17-103-MPR – TOY BARN

MPR (Minor Project Review) for an existing, auto-oriented campus located on separate parcels.

A MPR for signs and exterior modifications for two sites containing four existing buildings within the Toy Barn automotive campus.

5016 and 5002 Post Road

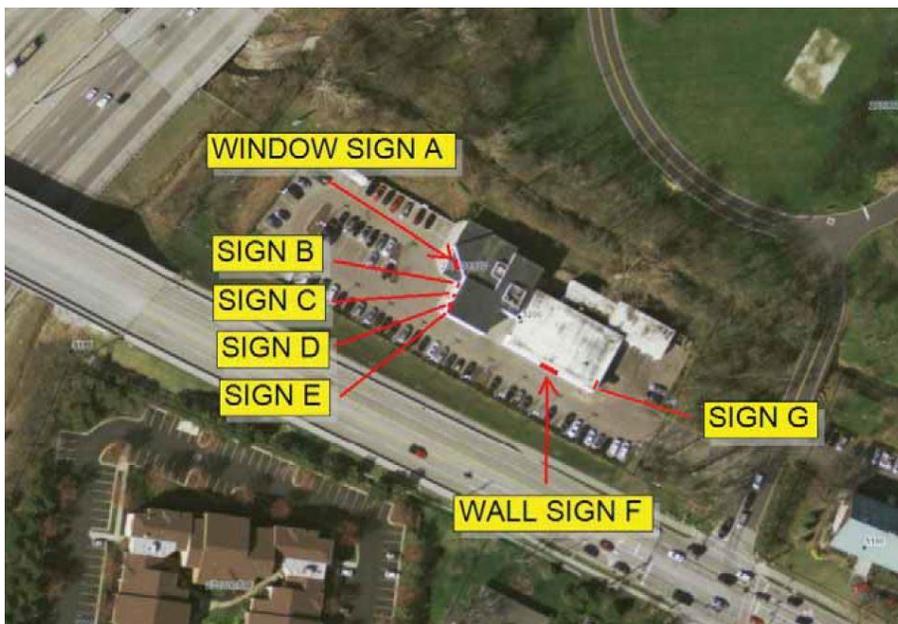
- Removal of four existing signs window signs, and two existing window signs to remain, and two new ground signs oriented toward different public rights-of-way.
- Post Road and Kilgour Place Ground Sign: The signs are proposed at 28.57 square feet each (or a total of 57.41 square feet) featuring three colors (white, red, and black). The total height of the signs combined is 11 feet – 8 inches. The sign cabinet is on top of a masonry base. The BSD Sign Design Guidelines strongly encourages ground signs that are dimensional and not simply flat. The applicant should update the signs to provide a dimensional ground sign in keeping with the intent of the BSD.

- Since the use has greater than 100-feet of frontage on two public rights-of-way two ground signs are permitted provided that combined they are not larger than one and a third times the permitted area (66.66 square feet) or one and a third times the permitted height (20 feet). The two sign may not be closer than two-third length the longest public ROW frontage (approximately 520 feet). This separation requirement should be shown on the plans and verified by Building Standards prior to issuance of a sign permit. Evergreen landscaping is proposed around the base. In all cases ground signs must be a minimum of 8 feet from the ROW and not located with an easement. The site plan provided with the sign permit should demonstrate this to the satisfaction of the City Engineer.

- Two window signs are proposed to remain, one per building, the total area of both signs is 8.24 square feet. When added to the area of the ground signs the total area of signs is within the area permitted for the site at 65.65 square feet.

- 1) The ground sign design be modified, subject to Planning's approval prior to sign permitting, to be dimensional letters;
- 2) The ground signs separation requirement should be shown on the plans and verified by Building Standards prior to issuance of a sign permit;
- 3) Both ground signs must be a minimum of 8 feet from the ROW and not located with an easement. The site plan provided with the sign permit should demonstrate this to the satisfaction of the City Engineer; and,
- 4) All directional signs meet Code.

A. 5200 Post Road

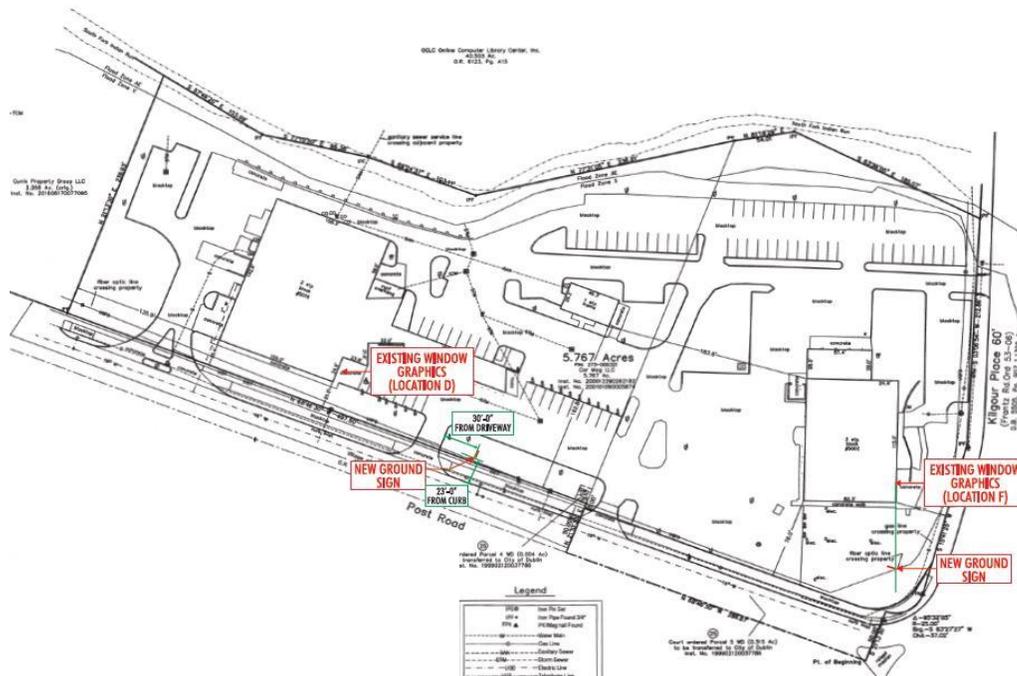
- Removal of five existing signs, and two existing signs to remain (one wall, and one window sign).
- Wall Sign: One sign is proposed on the south elevation of the building at 60.28 square feet in area, 13-feet in height, and three colors (white, red, and black).
- Window Sign: One sign is proposed on the west elevation above the entrance at five square feet and two colors (white and red).
- The total permitted sign area is 80 square feet, which the proposal falls within. All other considerations including secondary copy and logo size are less than 20-percent of the maximum sign area as proposed.
